Access Compliance Report Public Rights-of-Way (Curb Ramps)

Main Street: CLYDESDALE_DR Cross Street: COUSTEAU_LN Location: SE

ADA ID: RPRK211110134957 Ramp Type: Type 1 - Perpendicular Initial Pass/Fail: Fail Overall Compliance: No Severity Score: 15

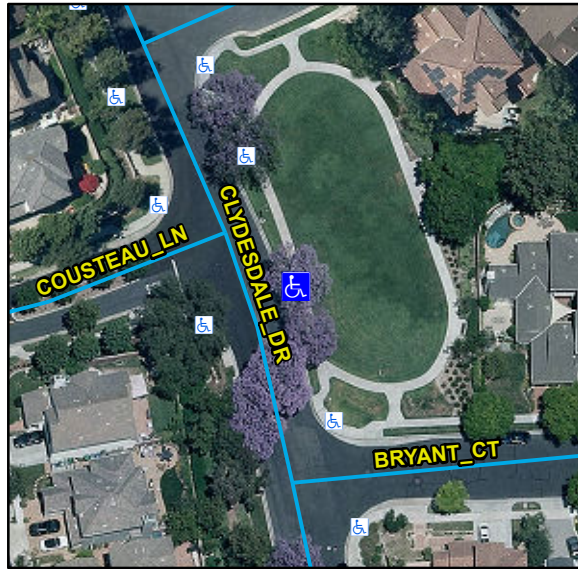
Compliance	Description	Data	Compliance	Description	Data
N/A	Ramp Length (in)	69	N/A	Flare Type LT	
Yes	Ramp Width (in)	48			N/A
No	Ramp Run Slope (%)	9.9	N/A	Flare Slope LT (%)	N/A
Yes	Ramp Cross Slope (%)	1.9	N/A	Flare Traversable LT	N/A
N/A	Landing Present	N/A	N/A	Flare Type RT	
N/A	Landing Length (in)	N/A			N/A
N/A	Landing Width (in)	N/A	N/A	Flare Slope RT (%)	N/A
N/A	Landing Run Slope (%)	N/A	N/A	Flare Traversable RT	N/A
N/A	Landing Cross Slope (%)	N/A	N/A	DWS Provided	N/A
N/A	Landing Movement Obstructed?	N/A	N/A	DWS Contrast	N/A
	Landing Movement Type	N/A	N/A	DWS Length (in)	N/A
N/A	Landing Shared	N/A	N/A	DWS Full Width	N/A
N/A	Clear Space	N/A	N/A	DWS Offset Left (in)	N/A
N/A	Clear Space To Crosswalk (in)	N/A	N/A	DWS Offset Right (in)	N/A
N/A	Marked Crosswalk 1	No	N/A	Marked Crosswalk 2	N/A
	Crossing 1 Direction	W		Crossing 2 Direction	N/A
	Marked Crosswalk 1 Width (in)	N/A		Marked Crosswalk 2 Width (in)	N/A

N/A	Ramp Inside Crosswalk 1	N/A	Yes	Ramp Inside Crosswalk 2	N/A
	Crossing 1 Slope (%)	0.8		Crossing 2 Slope (%)	N/A
	Crossing 1 Cross Slope (%)	2.3		Crossing 2 Cross Slope (%)	N/A
N/A	Gutter Ponding	N/A	No	Curb Slope	12.1
Yes	Gutter Lip Height (in)	0		Road Run Slope (%)	N/A
N/A	Gutter Run Slope (%)	N/A		Road Cross Slope (%)	N/A
N/A	Gutter Cross Slope (%)	N/A			
Yes	Overall Surface Condition: Acceptable		No	Perp Joint Present	No
	Cross Gutter Present?	No		Spandrel Present?	No
	Replace Cross Gutter?	N/A		Replace Spandrel?	N/A

Remove & Replace Entire Ramp.

R304.2.2, R204.3, STD 1115
